FORD A4LD SUN GEAR, SUN GEAR SHELL, DIRECT CLUTCH DRUM, FORWARD CLUTCH DRUM, AND CENTER SUPPORT CHANGES

Technical Service Information

Figure 1

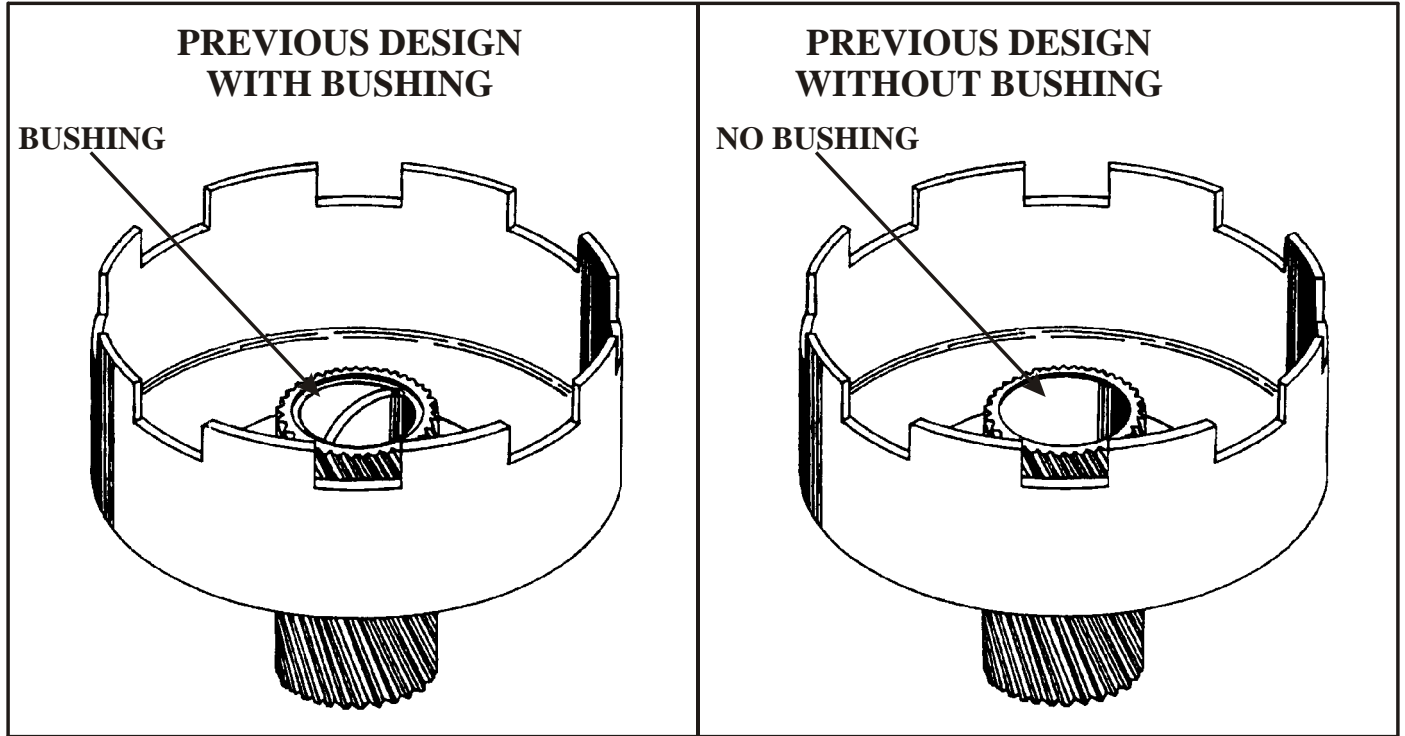
(1) **SUN GEAR** - Both bushings, inside the sun gear, were eliminated to allow full lubrication flow to the front planetary (See Figure 1).

- (1) The new design sun gear WITHOUT bushings WILL retro-fit back to all previous models (See Figure 1).
- (2) The previous design sun gear WITH the bushings CANNOT be used forward into the 4.0L models (See Figure 1).

Figure 2

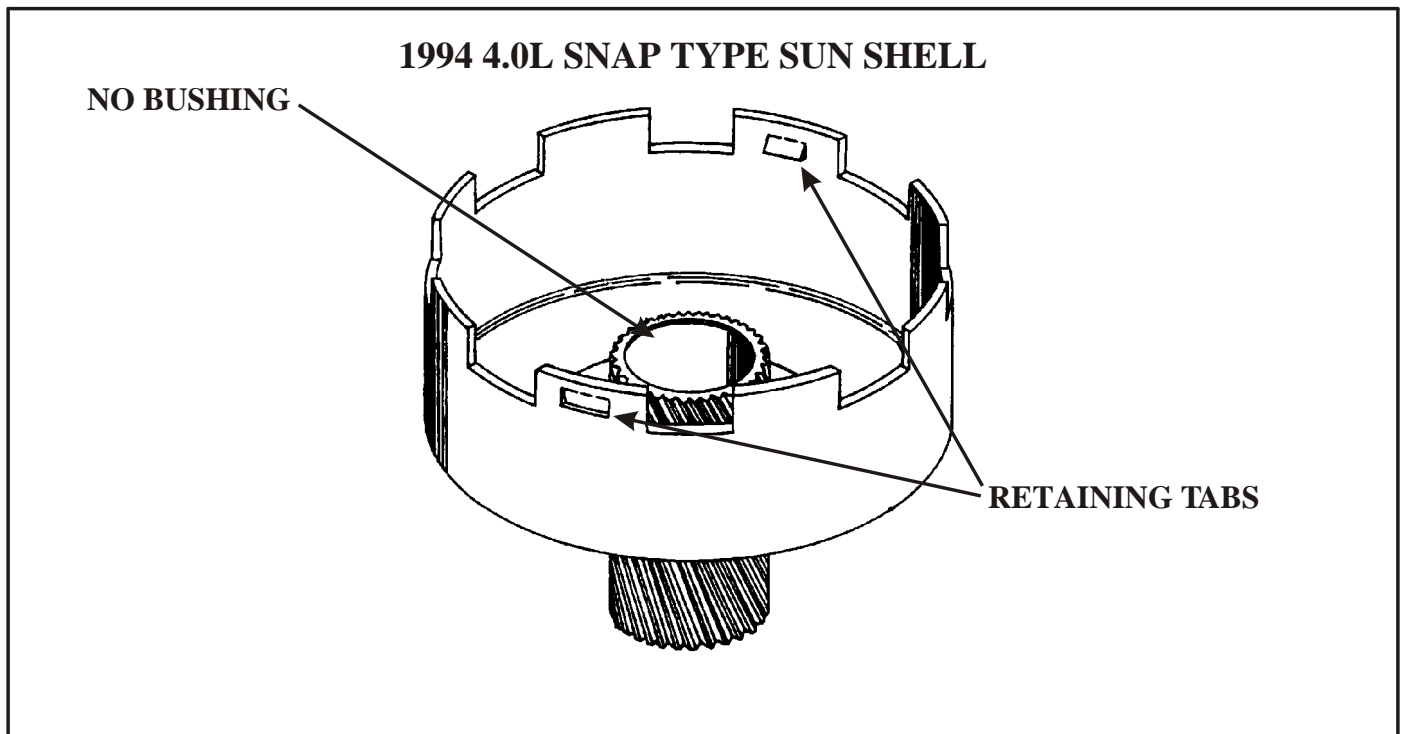
(2) **SUN GEAR SHELL** - “Snap Shell” was introduced in 1993 4.OL models, and has two retaining tabs stamped into the sides 180° apart, as shown in Figure 2. These tabs are used to retain the new direct clutch drum in the sun gear shell.

- (3) The new design “Snap Shell” must only be used with the direct clutch drum that is machined to accept the retaining tabs (See Figure 3).
- (4) The direct clutch drum WITH the machined groove for the “Snap Shell” WILL retro-fit back to ALL previous models (See Figure 3).

Figure 3

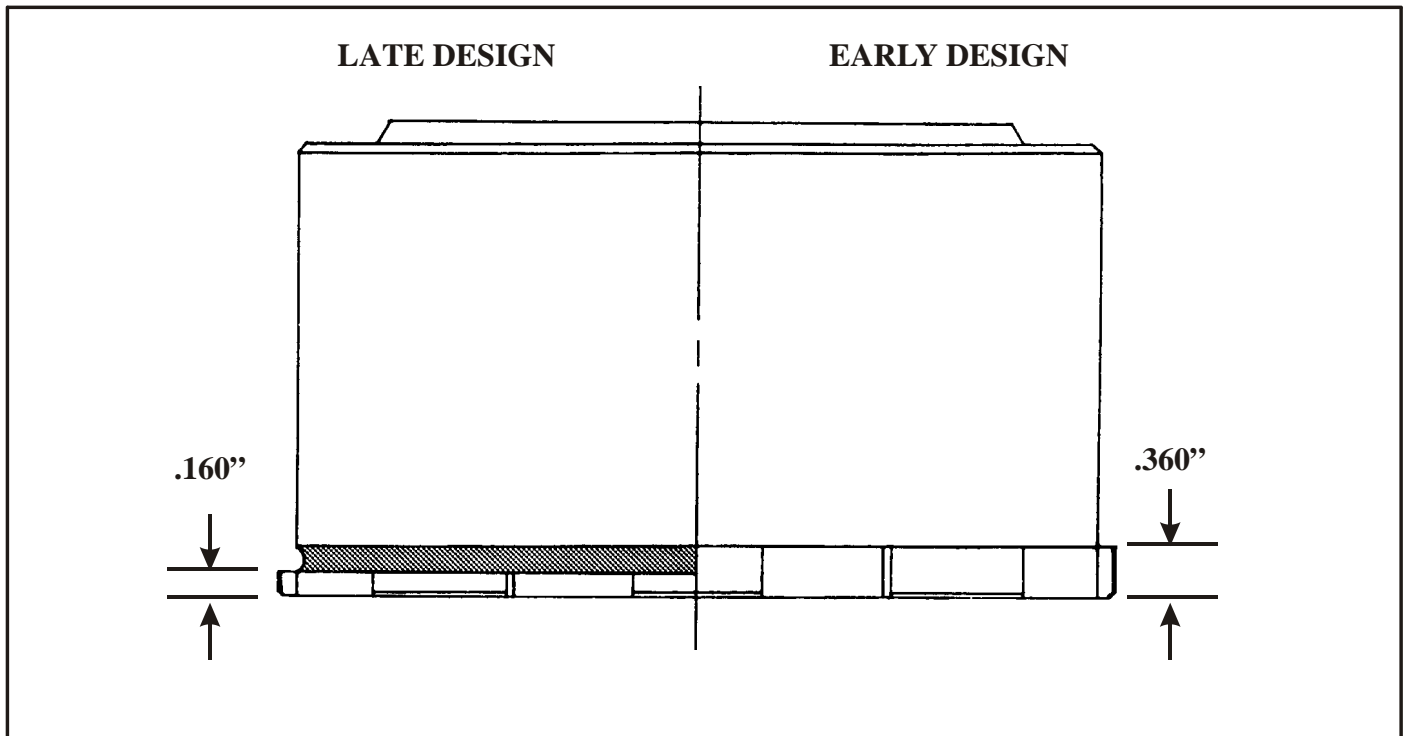
(3) **DIRECT CLUTCH DRUM** - The “Lug” area where the direct clutch drum engages the sun gear shell, was machined approximately .200” thinner, and a -.050” deep groove was machined into the drum to accommodate the added retaining tabs on the “Snap Shell” (See Figure 3). This now allows the sun shell and the direct drum to “Snap” together for easier assembly (See Figure 4). This change also allows the elimination of the number 4 thrust washer, located between the direct clutch drum and center support.

Figure 5

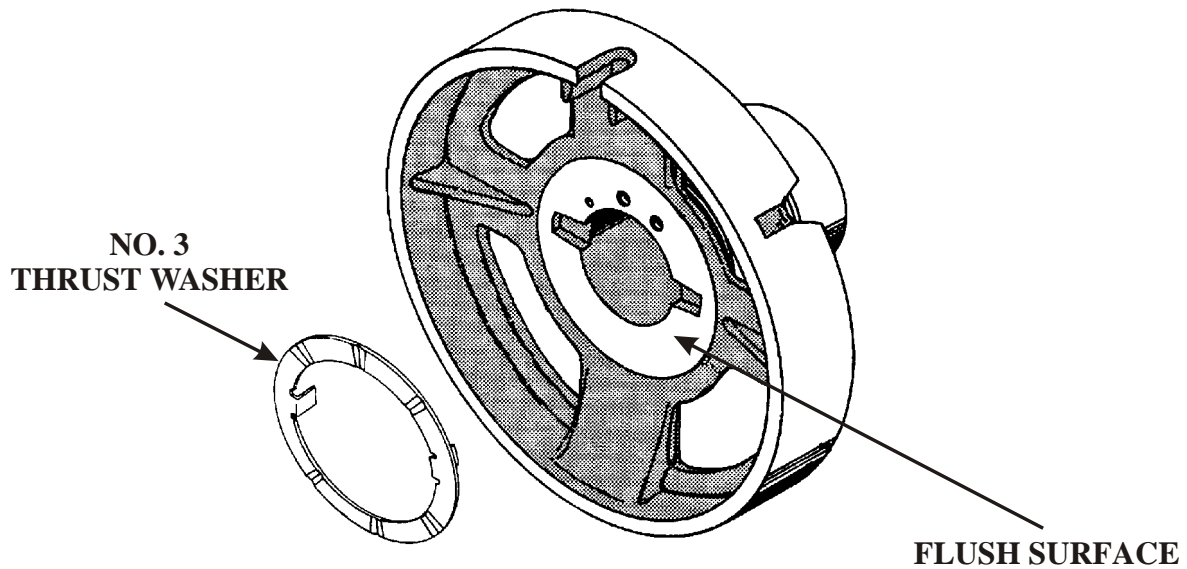
(4) **CENTER SUPPORT** - When the “Snap Shell” was introduced in 1993, the number 3 thrust washer was eliminated (See Figure 5), and number 3 thrust bearing was added (See Figure 6). The addition of the number 3 thrust bearing required machining the surface deeper to accommodate the bearings added thickness (See Figure 6). The new design center support also has a machined recess at the base of the sealing ring hub to accommodate the newly added number 5 thrust bearing (See Figure 8). Remember, the number 4 thrust washer was eliminated when this change occurred (See Figure 7).

- (6) The previous design center support CANNOT be used forward into ANY model that is using the “Snap Shell” (See Figure 5).
- (7) The new design forward clutch drum WILL retro-fit back on ALL previous models. (See Figure 9).

Figure 6

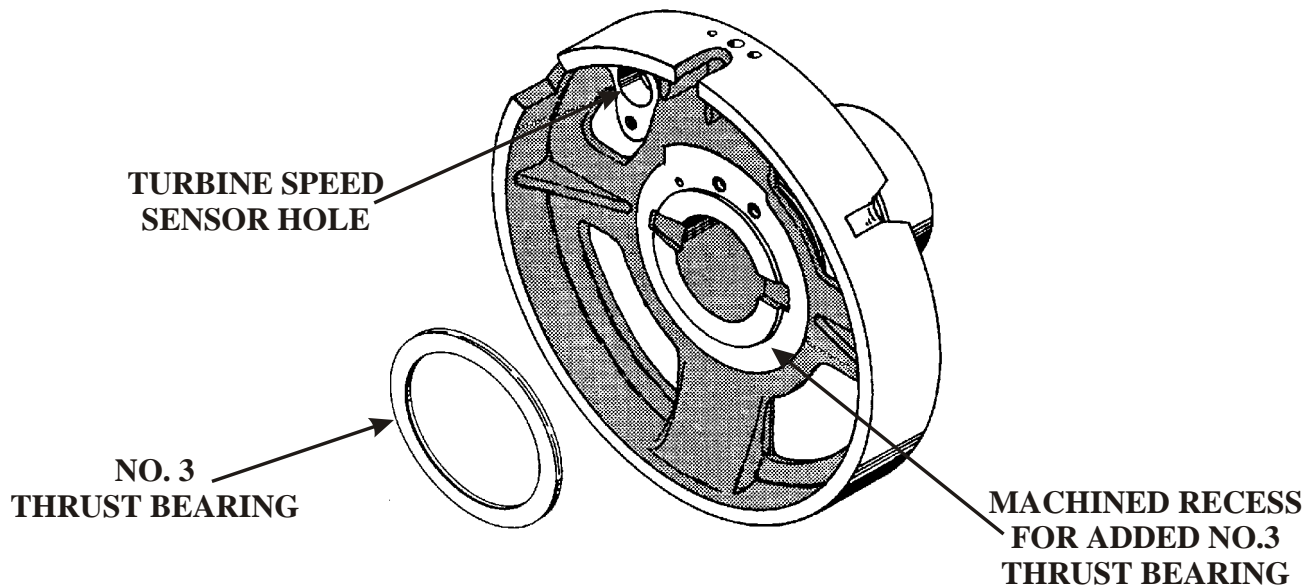
1. Machined recess for added number 3 thrust bearing (See Figure 6).
 2. Machined recess for added number 5 thrust bearing (See Figure 8).
 3. Machined hole for turbine speed sensor getting ready for 4R55E (See Figures 6 and 8).
- NOTE: Some new design center supports are cast for, but no hole has been machined.
4. Casting number on new design center support is 92GT-7L328-AA.

- (5) The new design level center support CANNOT be used in ANY previous models, unless updated with ALL of the parts listed above (See Figures 6 and 8).

Figure 9

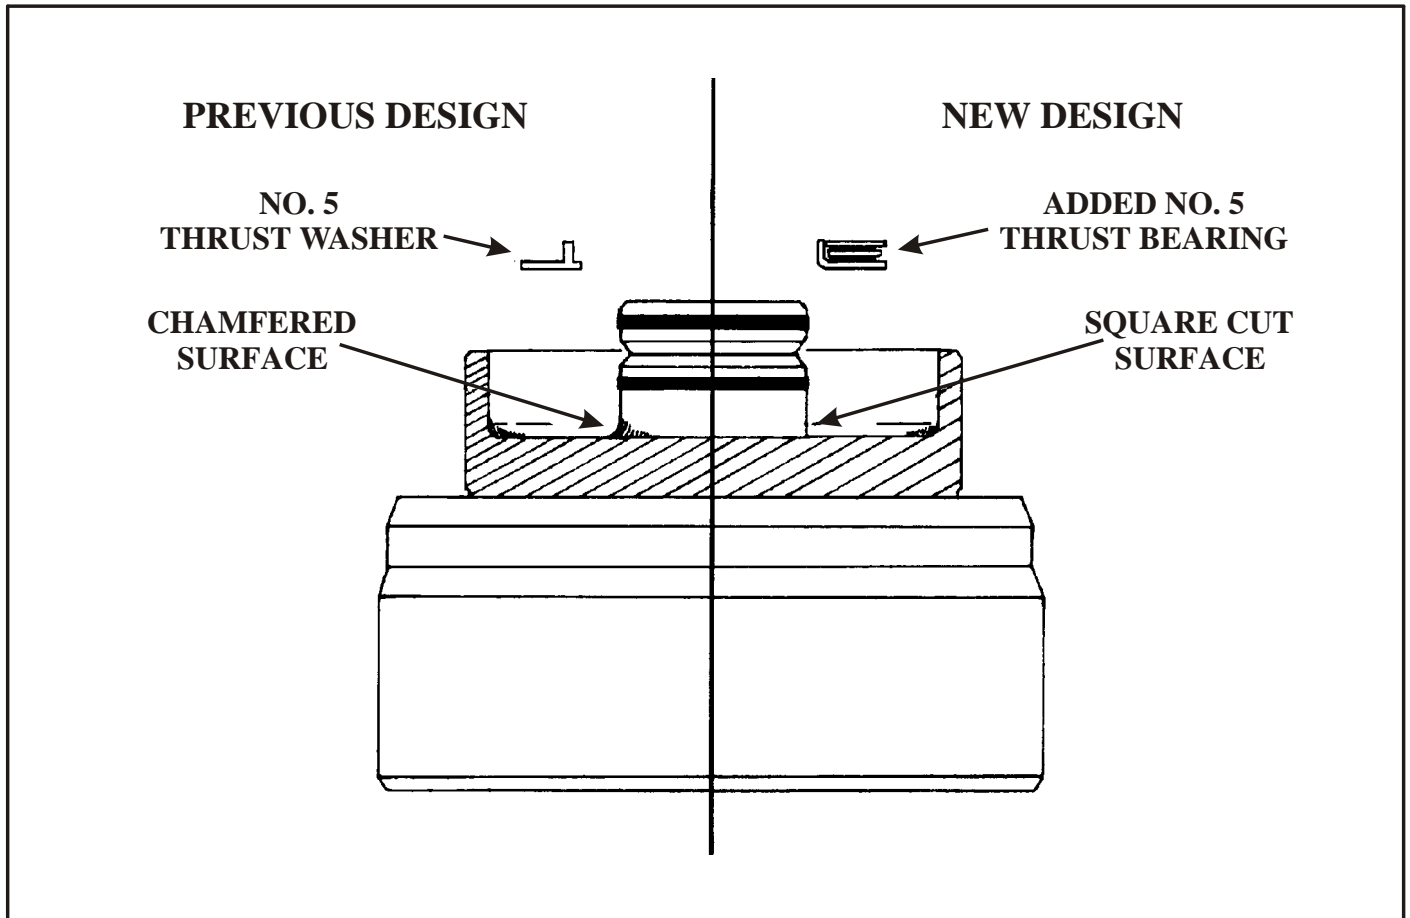
(5) **FORWARD CLUTCH DRUM** - Was machined at the base of the sealing ring hub to eliminate the chamfer, and provide a flat surface to accommodate the added number 5 thrust bearing, as shown in Figure 9.

- (8) The previous design forward clutch drum CANNOT be used in 1993 and later models, as the chamfered area at the base of the hub will not let the number 5 bearing seat properly (See Figure 9).
